# Access Compliance Report

## Public Rights-of-Way

### (Curb Ramps)

Intersection ID: 15205	Main Street: CHEROKEE_RD	Cross Street: FENTON_PL	Location: NW
ADA ID: B37AF3132050	Ramp Type: Directional1	Initial Pass/Fail: Fail	Overall Compliance: No
Severity Score: 25			
Codes/Mitigation Info/Possible Solution		Field Measurements/Component Compliance

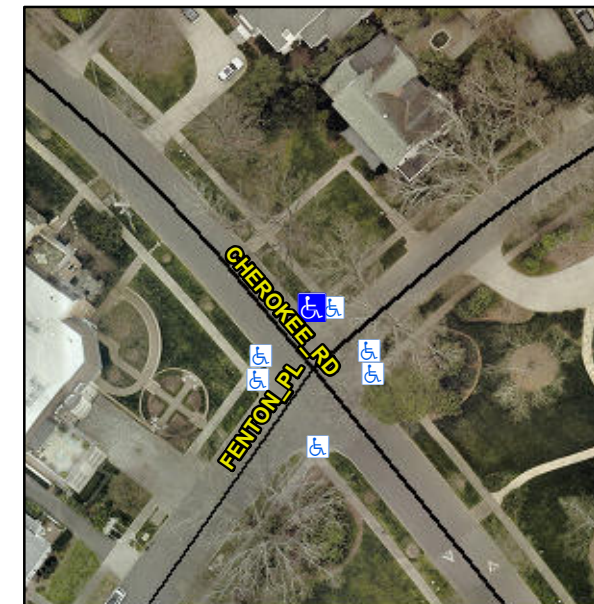
**R304.2.2, R304.5.3**

Compliance	Description	Data	Compliance	Description	Data
N/A	Ramp Length (in)	40.0	N/A	Grade Break?	N/A
Yes	Ramp Width (in)	51.0	N/A	Grade Break Slope (%)	0.0
No	Ramp Slope (%)	9.7	N/A	Grade Break XSlope (%)	0.0
No	Ramp XSlope (%)	5.2			
N/A	Flare Type LT	N/A	N/A	Flare Type RT	N/A
N/A	Flare Slope LT (%)	N/A	N/A	Flare Slope RT (%)	0.0
N/A	Flare Traversable LT?	N/A	N/A	Flare Traversable RT?	N/A
N/A	Landing Length (in)	0.0	N/A	DWS Provided?	N/A
N/A	Landing Width (in)	0.0	N/A	DWS Contrast?	N/A
N/A	Landing Slope (%)	0.0	N/A	DWS Length (in)	N/A
N/A	Landing X Slope (%)	0.0	N/A	DWS Full Width?	N/A
N/A	Landing Curb? (Y/N)	N/A	N/A	DWS Offset LT (in)	N/A
N/A	Shared Landing?	N/A	N/A	DWS Offset RT (in)	N/A
N/A	Gutter Ponding?	0.0	N/A	Gutter Slope (%)	N/A
N/A	Gutter Lip Ht (in)	0.0	N/A	Gutter X Slope (%)	N/A
N/A	Painted X Walk1?	No		Road Slope (%)	5.2
	X Walk 1 Direction	To SW		Road X Slope (%)	1.3
	X Walk 1 Width (in)	N/A		Clear Space?	N/A

X Walk 1 Slope (%)	5.2	N/A	Clear Space to XWalk (in)	N/A
	X Walk 1 X Slope (%)	1.3	N/A	Storm Grate/Utility Hazard?	N/A
N/A	Ramp inside XWalk1?	N/A		Storm Grate/Utility Type	
N/A	Any Obstructions?	N/A			N/A
	Obstruction Type		Yes	Surface Condition? (G/P)	Good
			N/A	Curb Slope (%)	14.4

**Remove & Replace Entire Ramp.**
